Pass Christian
Site Demolition and Site Work

00.901 ADDENDUM NO. 1
(This Addendum contains 2 pages, 4 attachments (8-1/2"x11"))

1 REVISED SITE FENCING PLAN

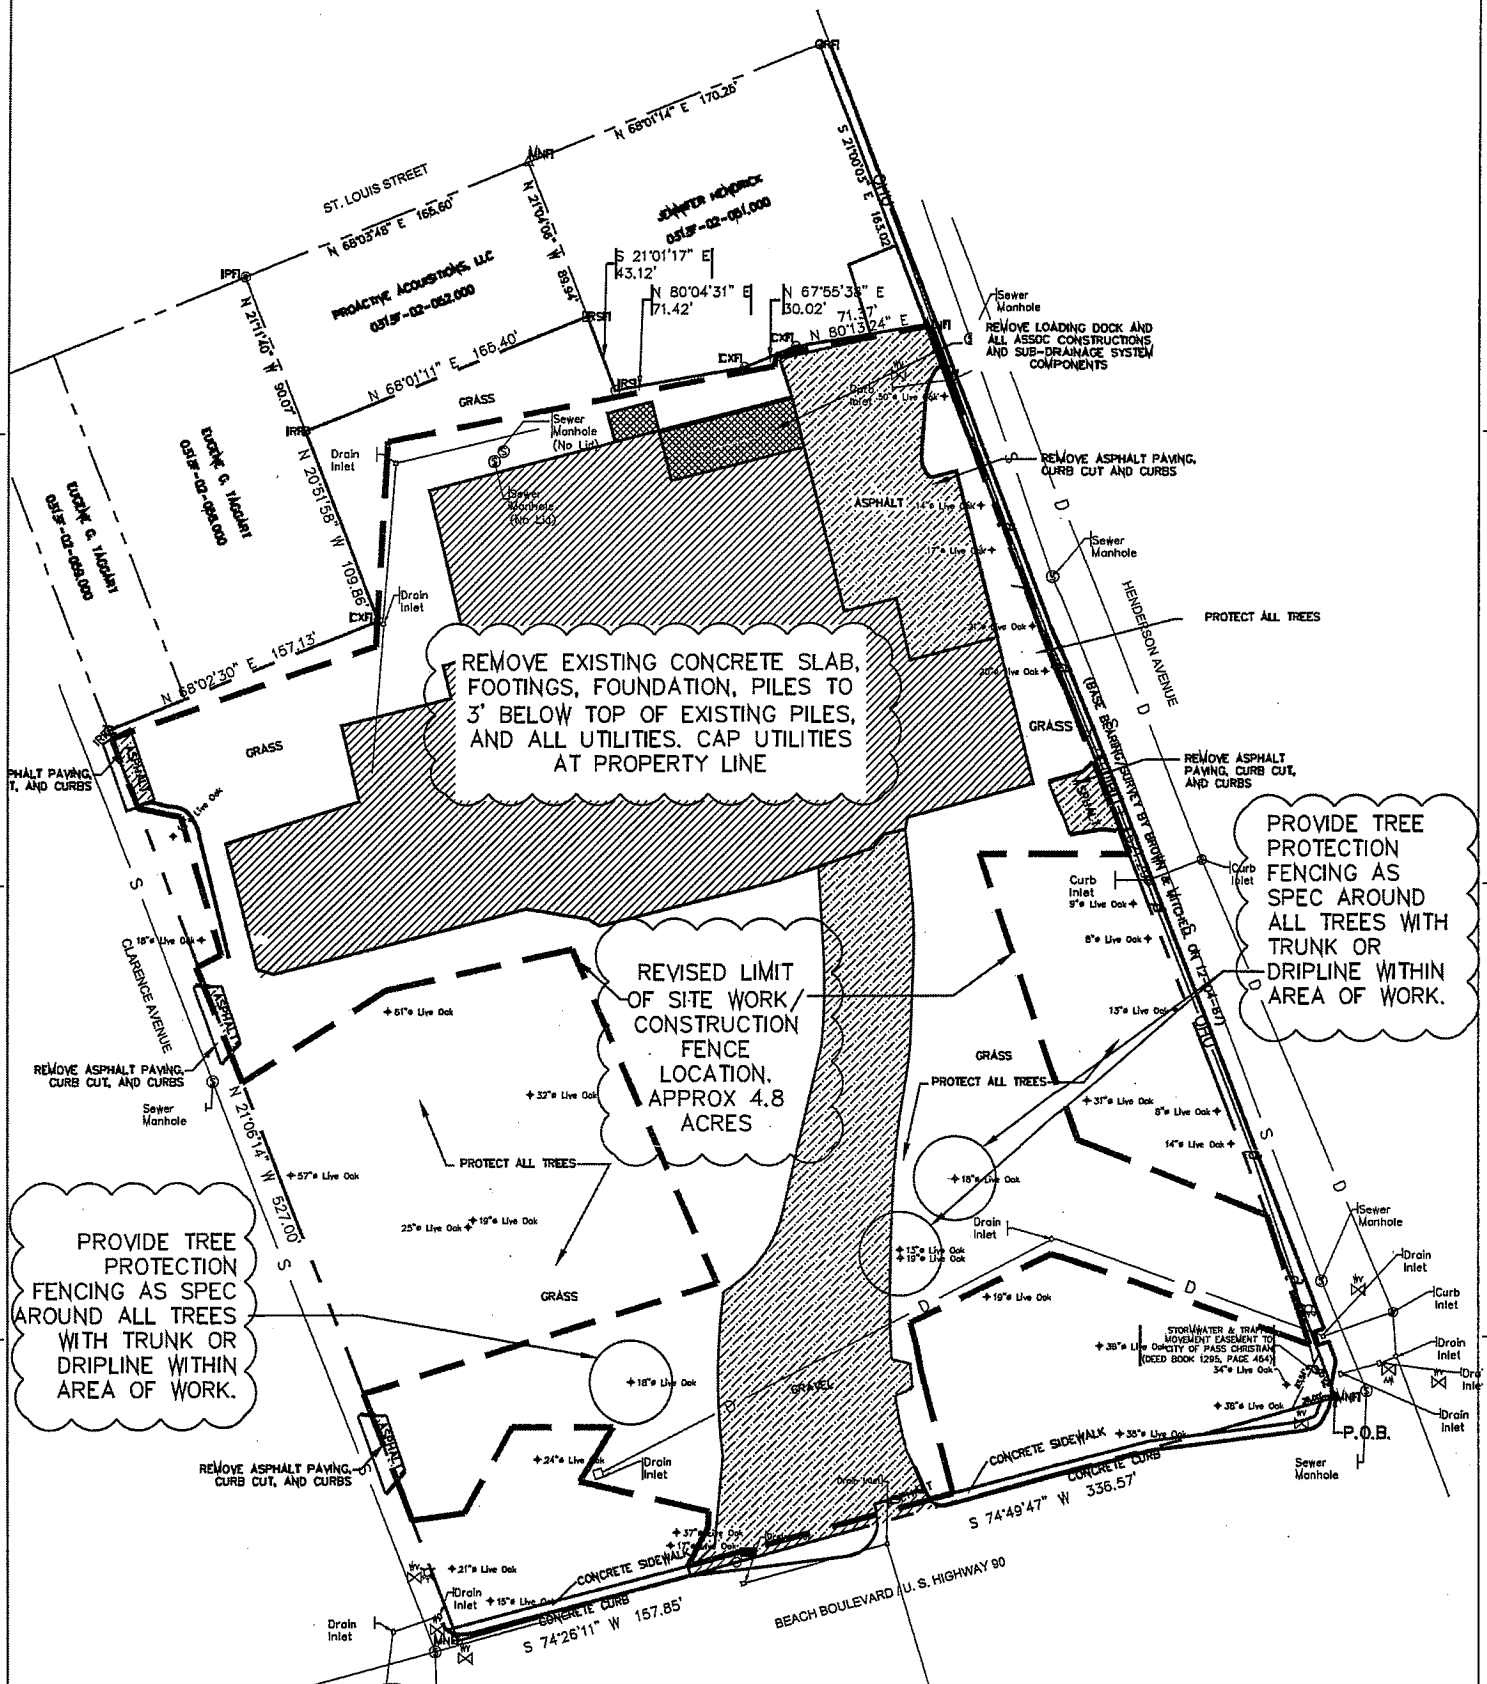
3. Sheet A-1:
   a. Revise 1/A-1 per attached AD1-A1 to show revised limits of site fencing and revised note for removal of pile.
4. Sheet A-2:
   a. Under Site Work Notes, revise note 4 to read, "Contractor shall provide topsoil and hydroseed over area of work (as delineated by temporary construction site fencing) only. See Sheet AD1-A1 for temporary construction site fencing."
